179th session
Geneva, 12-14 November 2019
Item 4.8.6 of the provisional agenda
1958 Agreement:
consideration of draft amendments to existing
UN Regulations submitted by GRSP

# **Proposal for Supplement 17 to the 04 series of amendments to UN Regulation No. 44 (Child Restraint Systems)**

## Supplement 17 the 04 series of amendments to UN Regulation No. 44 (Child Restraint Systems)

Figure A

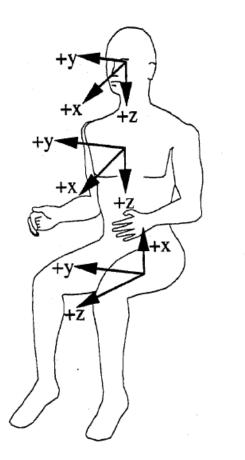
Amend paragraph 7.1.4.2.2. to read:

"7.1.4.2.2. The vertical component of the acceleration from the abdomen towards the head, "-z", when the measurement procedures defined in paragraph 8.5 of this document are followed, shall not exceed 30 g except during periods whose sum does not exceed 3 ms. The measurement procedures defined in paragraph 8.5 of this document follow those of ISO 6487 with SAE J211 sign convention, as shown in Figure A.
